**ADDENDUM #10
BID NO. 2009-V**

Project: Ellisville Water System Improvement – Expansion to US 441

Response to Requests for Additional Information #3

**RE: Ellisville Water System Improvement
Expansion to U.S. Highway 441
Request for Additional Information #3**

SINGLE YOKE BOX METER CONNECTION

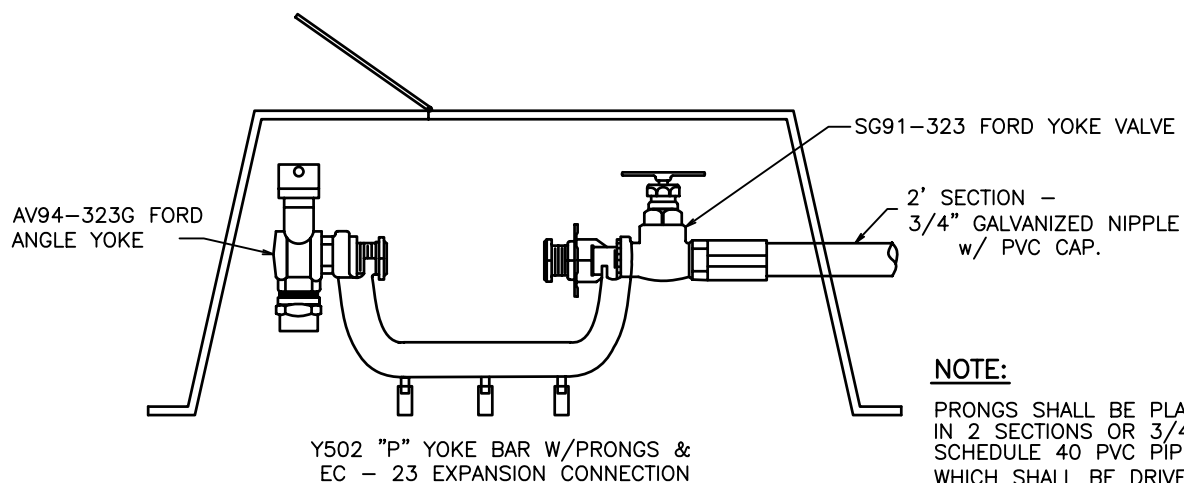
6. Please provide information on the services required on this project.

A detail and specification for the water services is attached to this memo.

A. The service line shall be 3/4" in size from the tap to the road right-of-way.

B. An EMS marker, Scotchmark #1257, shall be buried behind the buried angle meter valves. A 2 inch PVC pipe will be set vertically atop the angle meter valve and shall extend 2 feet above grade.

C. The angle meter valves shall be Mueller B-24273 or Ford AV94-323G.

D. Service taps shall have a minimum 7/8" (opening cut) in the saddle clamp. Saddle clamps shall be Romac Style 202N, double strap, nylon saddle with stainless steel straps, with cc tap. (Single strap saddle clamps prohibited).
